City of Charleston

BOARD OF ARCHITECTURAL REVIEW - LARGE

January 8, 2020

4-6 GADSDEN STREET
TMS #459-03-03-001

WEST ELEVATION | **334 KING**
BAR-201

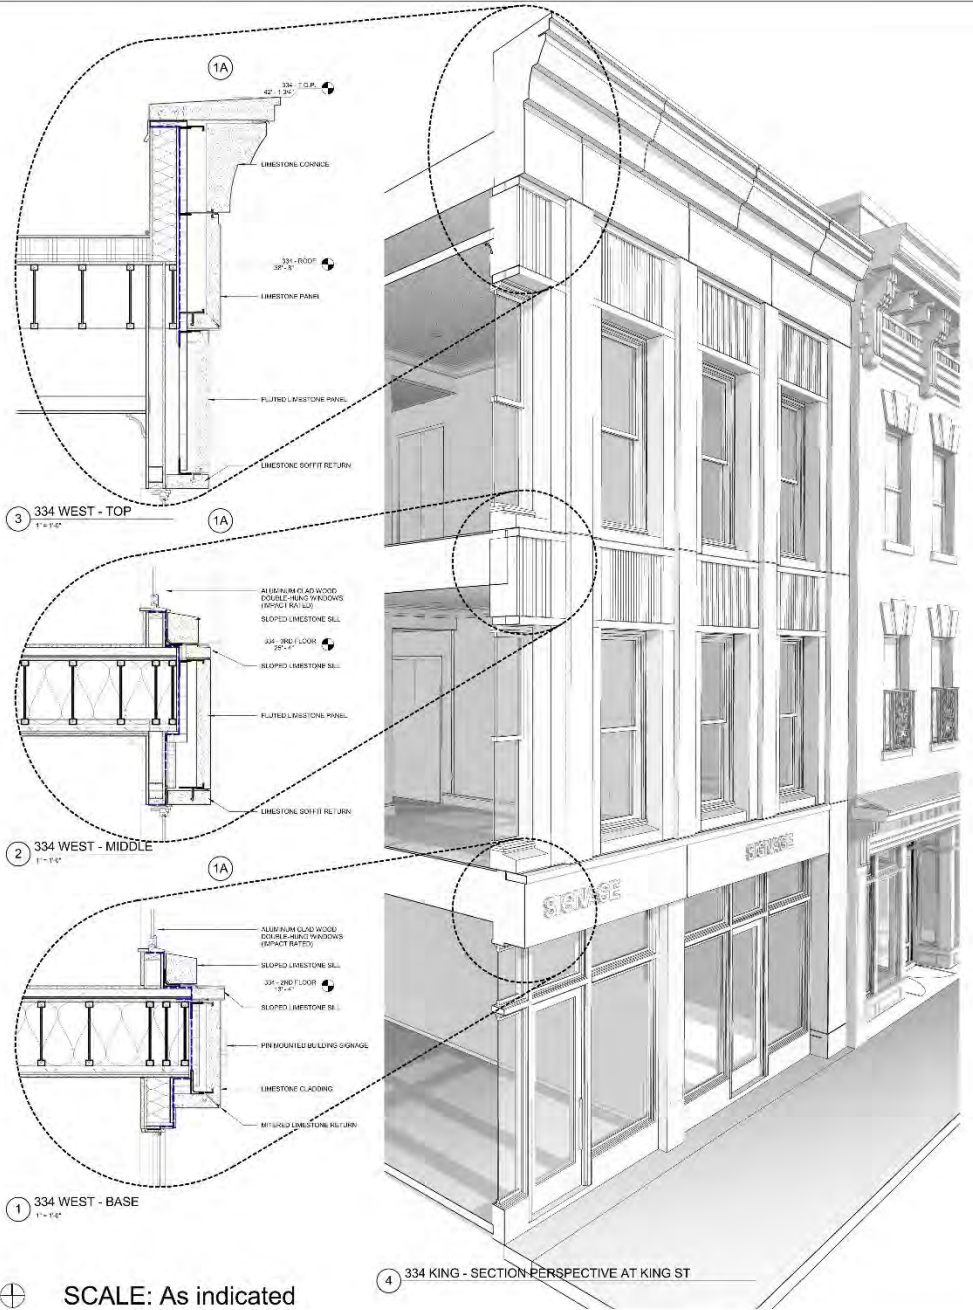
The applicant is seeking approval of a revised King Street facade design for the new building at 334 King Street. The previous design had received Final Details to Staff approval on 7/16/2019 and had been approved for a building permit. The design revisions proposed are limited to the King Street facade and include the following changes:

1. The 2nd and 3rd floor Juliet balconies are replaced with double-hung windows.
2. The metal railings are being removed.
3. The size of the openings have been reduced to be more similar to the scale of the window openings found on King Street.
4. The limestone joint spacing has been revised to have larger pieces of stone.
5. The depth of the openings and the pilaster detailing remains the same.
6. There are no changes at the ground floor or at the top cornice.

BAR-03

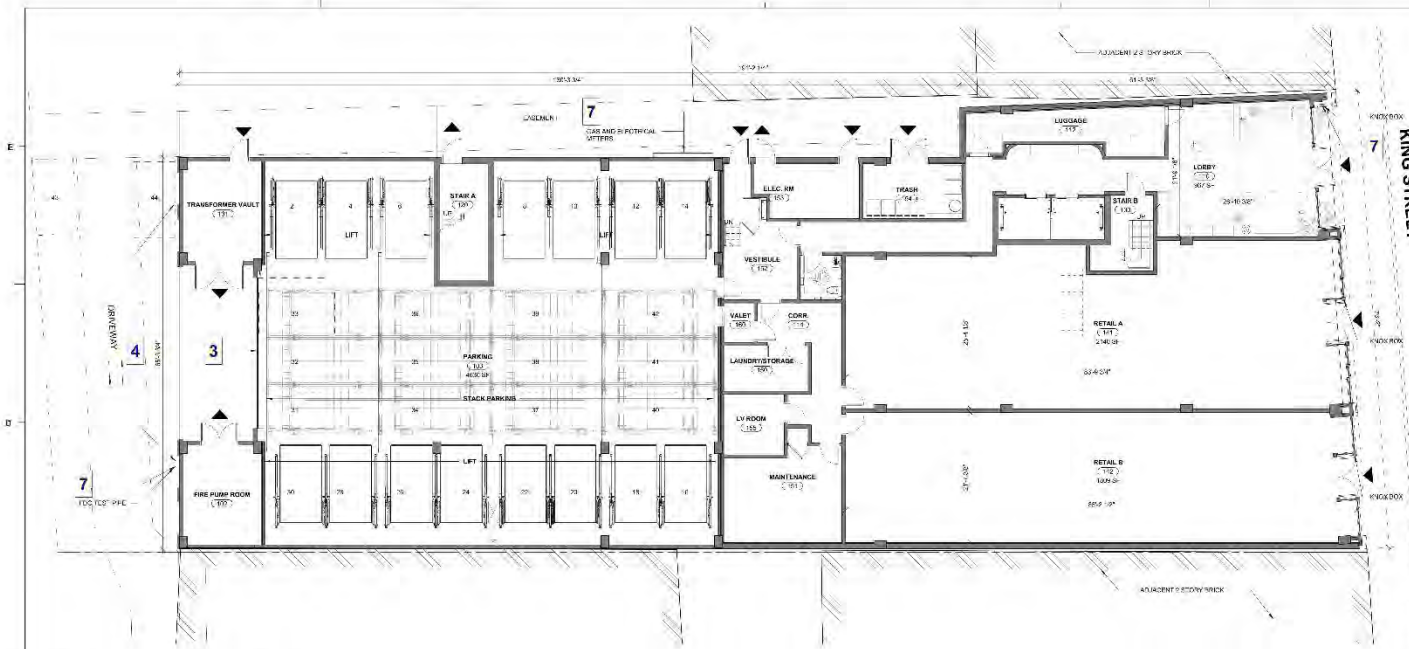
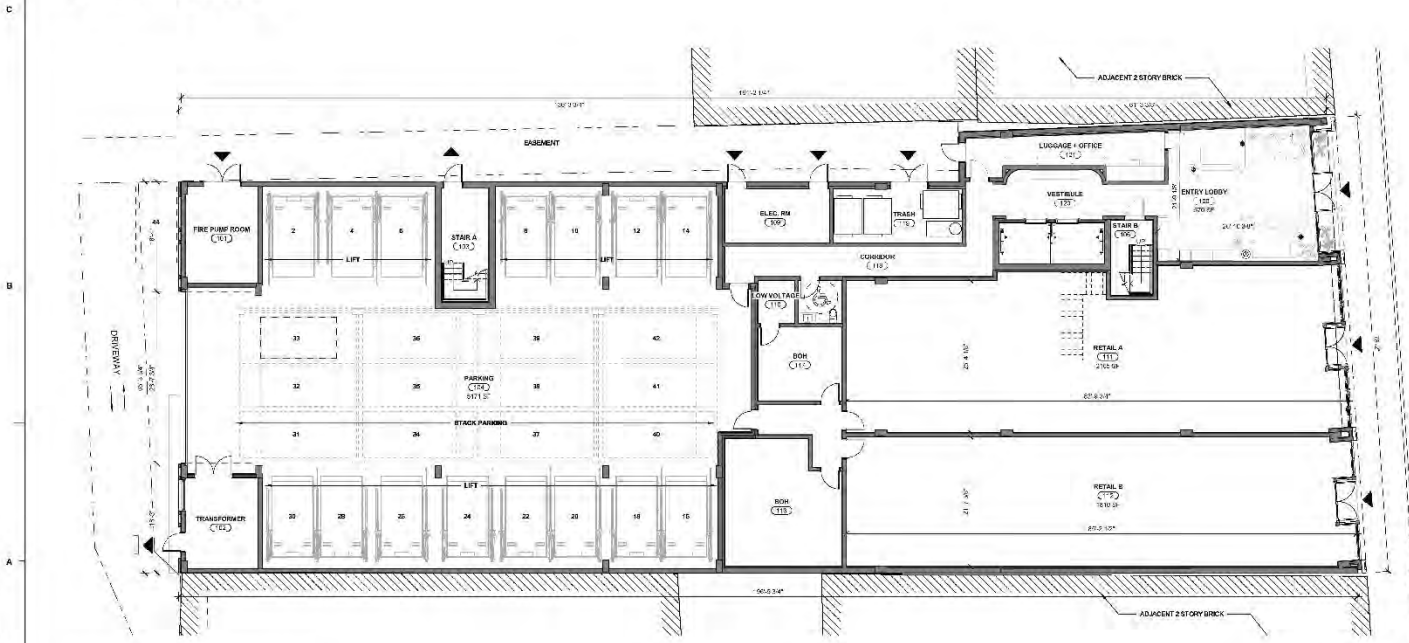
Board comment:

A. Reduce the visibility of the penthouse from King Street. - Response: The penthouse roof has been reduced by 1'. The canopy now extends around the corner to minimize the perception of the penthouse mass.

1. This continues to be an elegant project that will be a nice addition to King St. and welcome replacement of the existing building. - **Response: Noted**

2. Staff feels that the rooftop terrace should be held further back (at least 6'-0") from the edge of the building out of respect for King St. - **Response: Planter boxes have been added at the north-east and south east corner of the roof terrace to provide a 5' buffer.**

COMPARISON -
GROUND FLOOR
PLAN

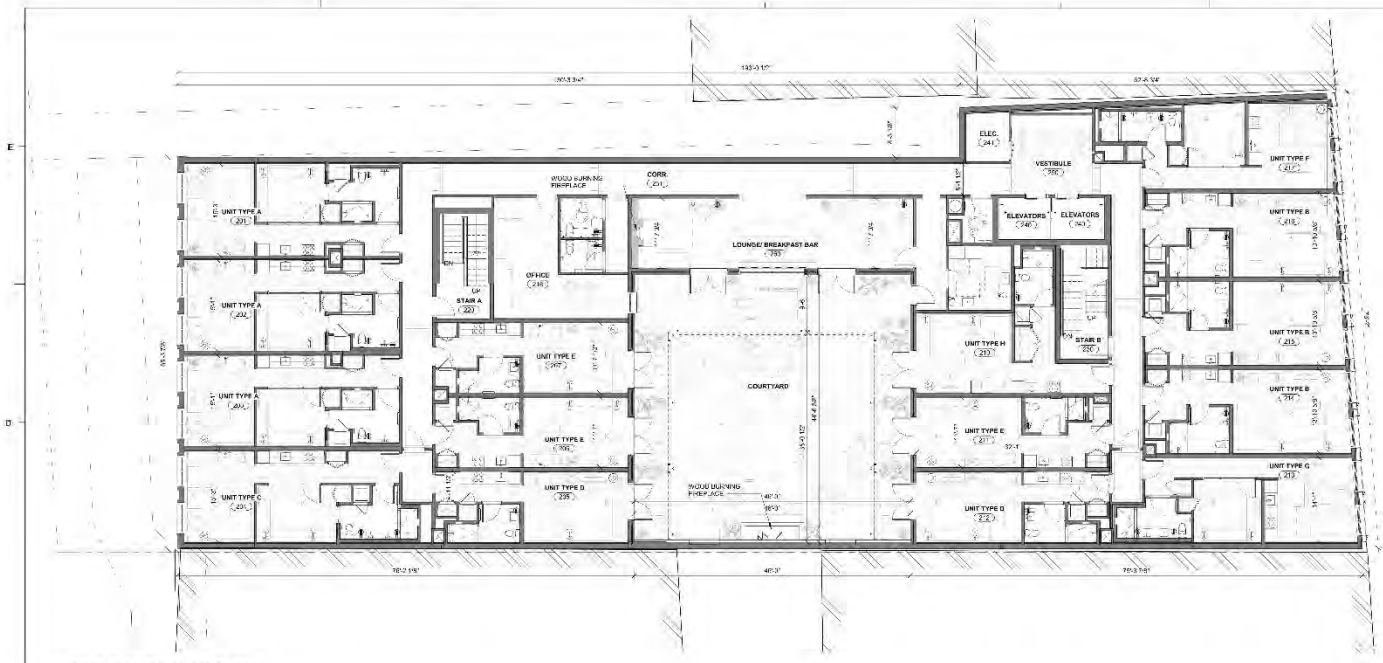
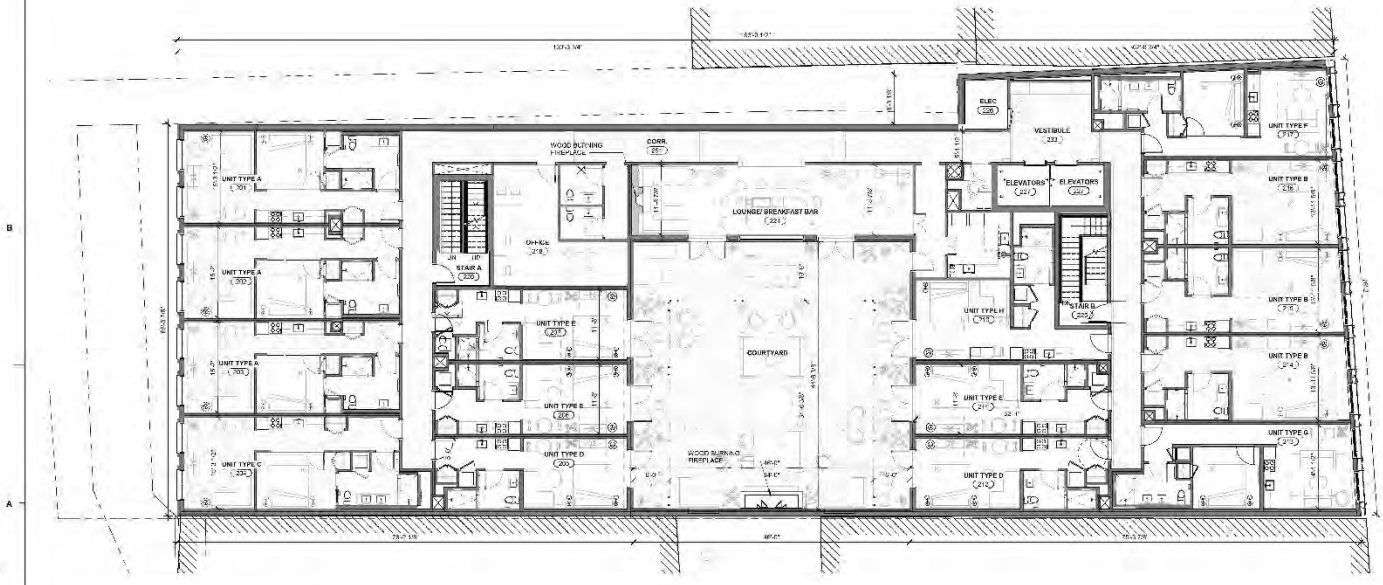
3. Relocate the garage door to the E. wall of the Transformer/Fire Pump Room to create a vestibule for the garage. Extend exterior wall finishes into the vestibule, provide a finished ceiling and appropriate lighting. - **Response: The garage door has been relocated as suggested. The exterior wall finishes have been extended into the vestibule as suggested and a finished stucco ceiling with lighting has been provided.**

- Relocate the garage door to the E. wall of the Transformer/Fire Pump Room to create a vestibule for the garage. Extend exterior wall finishes into the vestibule, provide a finished ceiling and appropriate lighting. – **Response: The garage door has been relocated as suggested. The exterior wall finishes have been extended into the vestibule as suggested and a finished stucco ceiling with lighting has been provided.**

- Staff feels the recesses in first floor of rear elevation should be eliminated and a louver added to the north of the garage entry for balance. Also, move the louver above the garage door with the garage door into the vestibule noted above. – **Response: The louvers and doors have been removed from the western facade. We believe that the recesses add texture and are a successful way of dealing with a blank facade**

COMPARISON -
ROOF PLAN

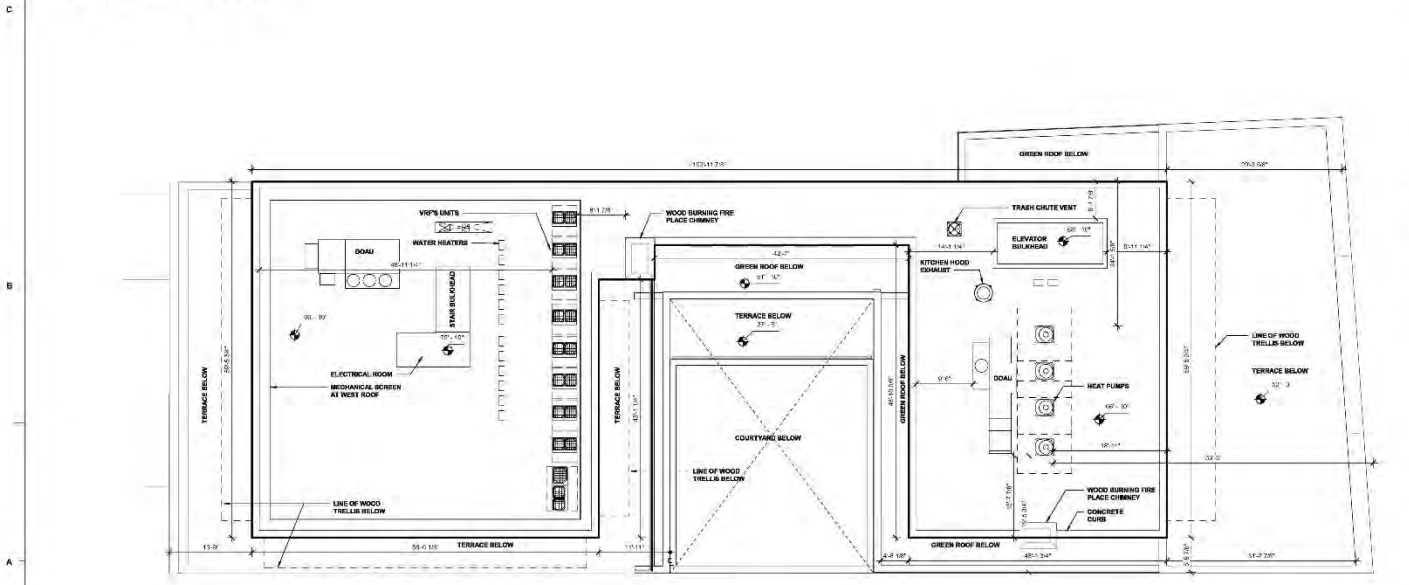
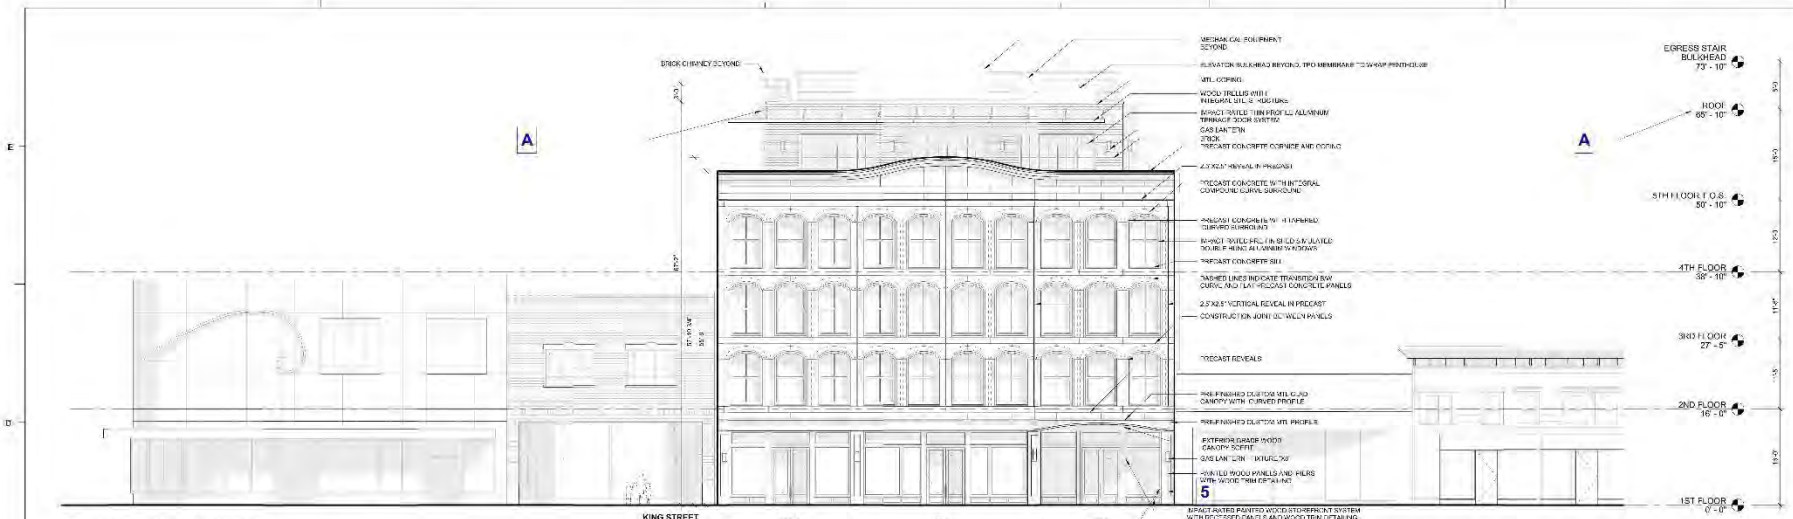
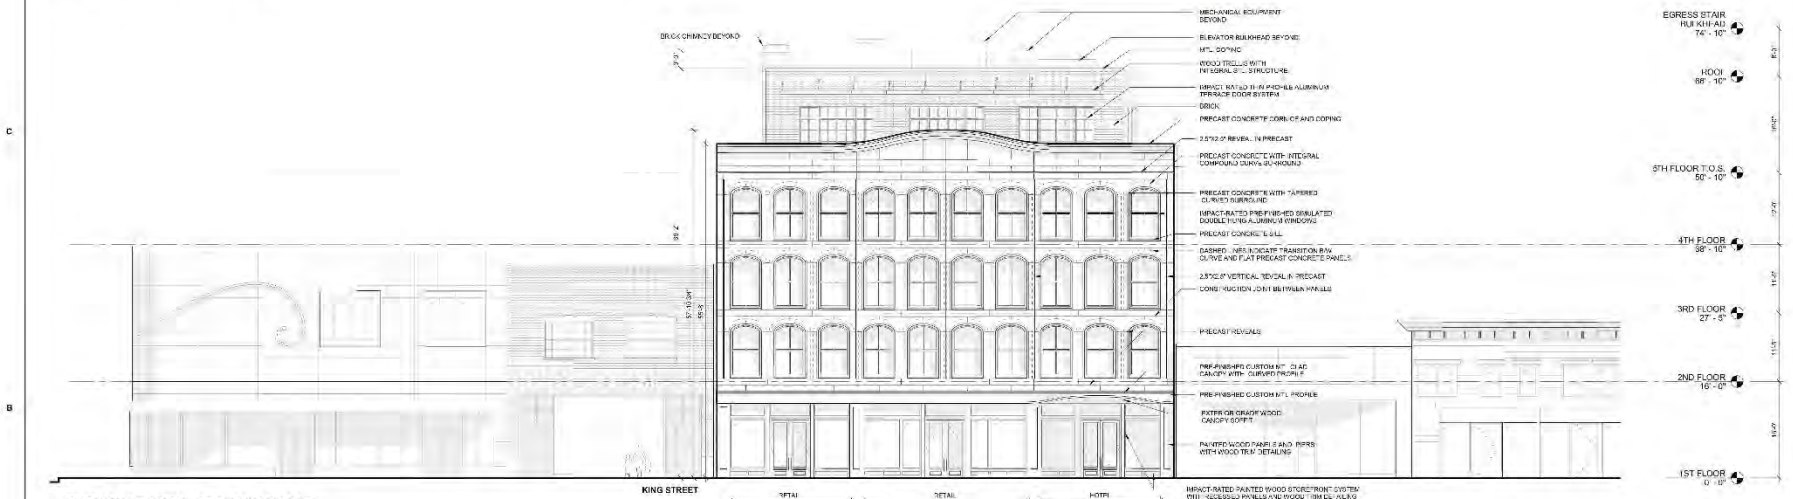
- Staff feels that the rooftop terrace should be held further back (at least 6'-0") from the edge of the building out of respect for King St. – **Response: Planter boxes have been added at the north-east and south east corner of the roof terrace to provide a 5' buffer.**

PROPOSED PERSPECTIVE

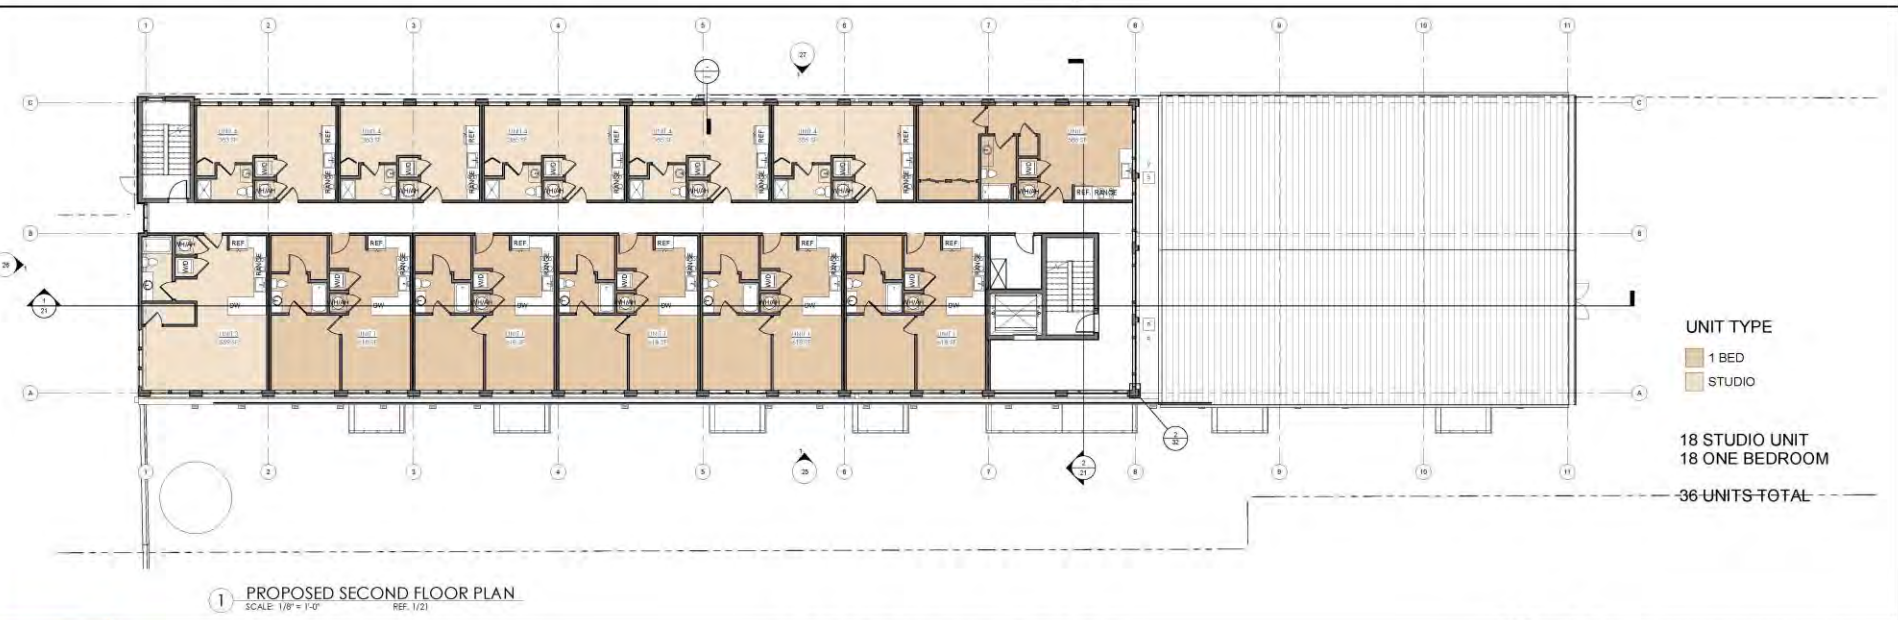
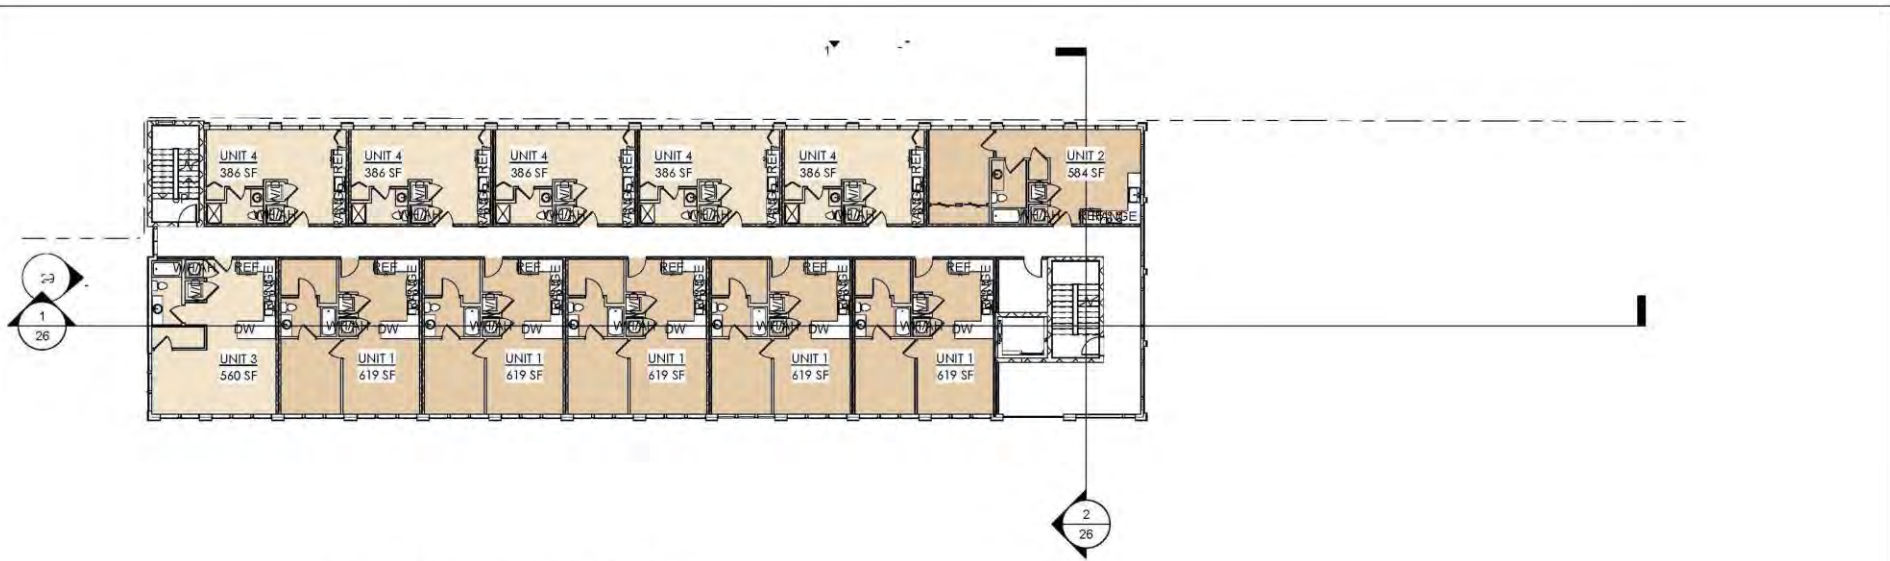
8. Research should be provided to justify the design of the gabled front of the existing building.
9. The roof of the existing building should be hand-crimped standing seam ferne metal.

10. The incomplete transition of metal and brick at the north wall (west end) needs to be resolved.

1. We agree with comment 1
2. We agree with comment 2
3. We agree with comment 3
4. The proposed color of the metal panel between pilasters is the similar color with the darker window color to emphasize the "column/beam with glass infill" nature of the design.
5. The proposed window is Sierra Pacific alum clad single/double hung window with authentic mullions.
6. The landscape design now matches the Trolley Barn
7. The paving at the parking now shows the same design with trolley Barn.
8. The photo of inside of the existing wall being provided on Sheet 23.
9. We agree with comment 9.
10. The new plan detail shows the transition of the metal and brick on Sheet 31.
